European Union Agency for the Cooperation
of Energy Regulators

Grid Connection NCs Amendments – update

ACER main changes from PC draft proposals for NC RfG amendment

ACER draft proposals – main changes (Requirements for Generators)

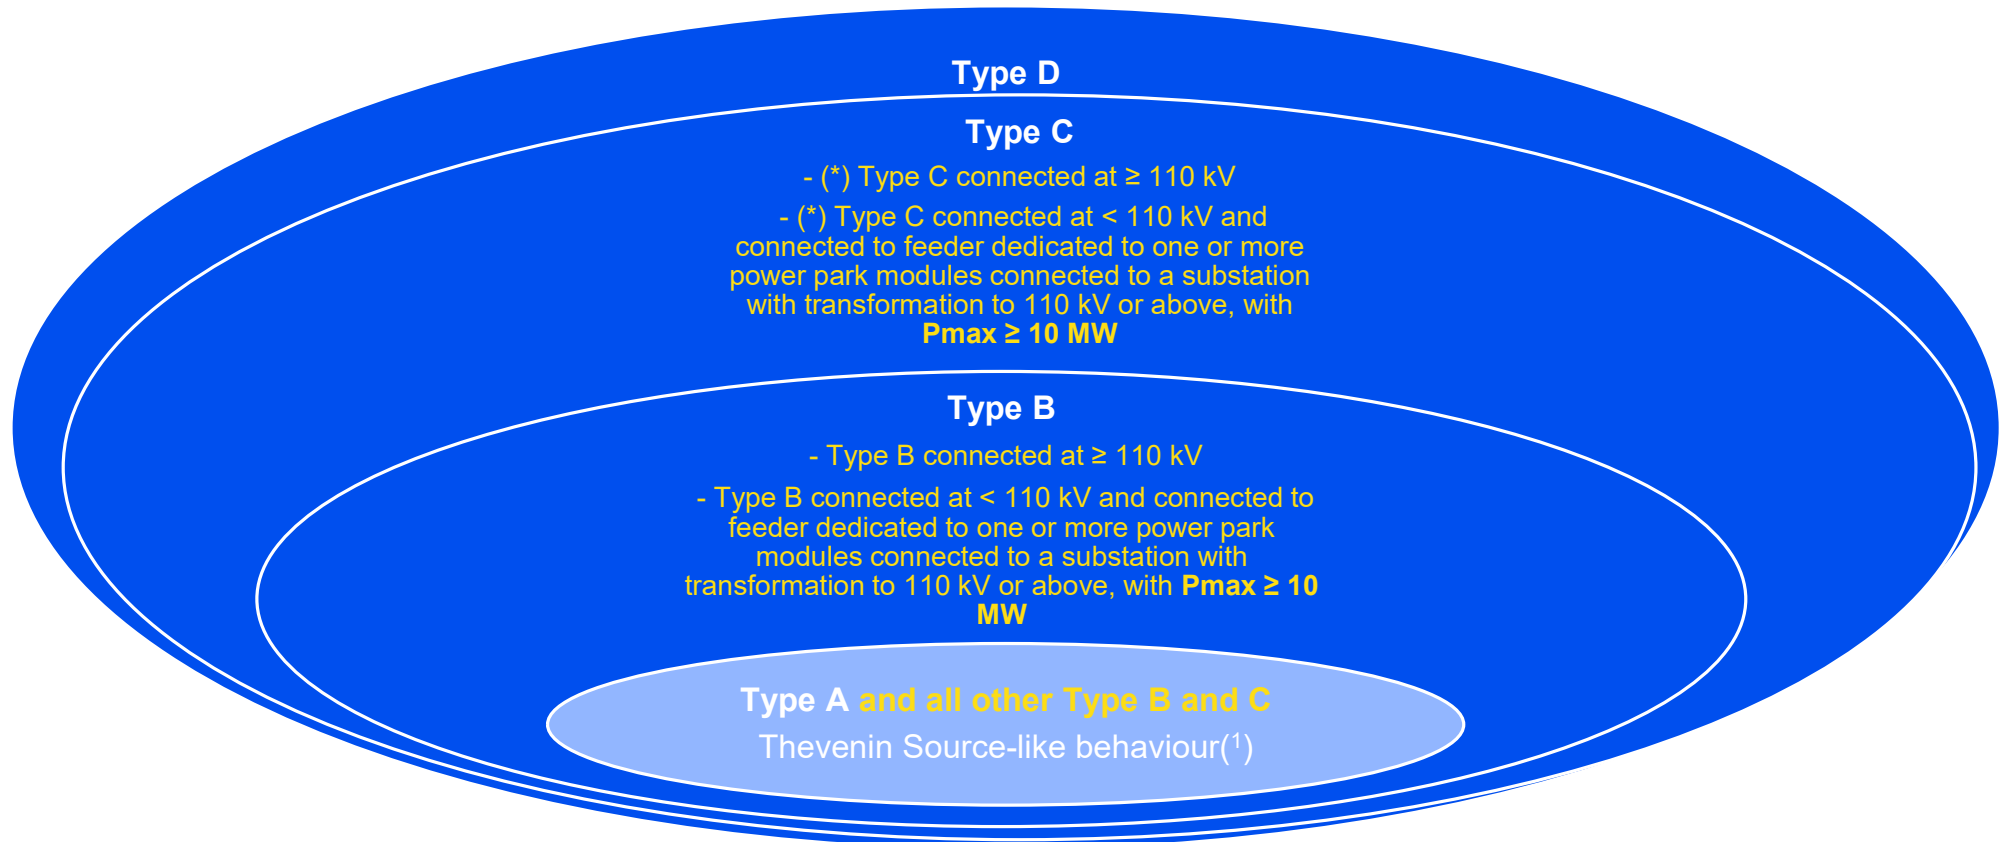
1) Staying connected to the network and operating at:

- $\pm 4,0$ Hz/s over a period of 0,25 s,
- $\pm 2,0$ Hz/s over a period of 0,5 s,
- $\pm 1,5$ Hz/s over a period of 1 s, and
- $\pm 1,25$ Hz/s over a period of 2 s;

2) Staying connected to the network and operating at the sequence defined by the frequency against time profiles

Staying connected to the network and operating at:

- $\pm 2,0$ Hz/s over a period of 0,5 s,
- $\pm 1,5$ Hz/s over a period of 1 s,
- $\pm 1,25$ Hz/s over a period of 2 s;

Staying connected to the network and operating at:

$\pm 1,0$ Hz/s over a period of 0,5 s

the relevant system operator, in coordination with the relevant TSO, and the power-generating facility owner may agree on a higher value of rate-of-change-of-frequency
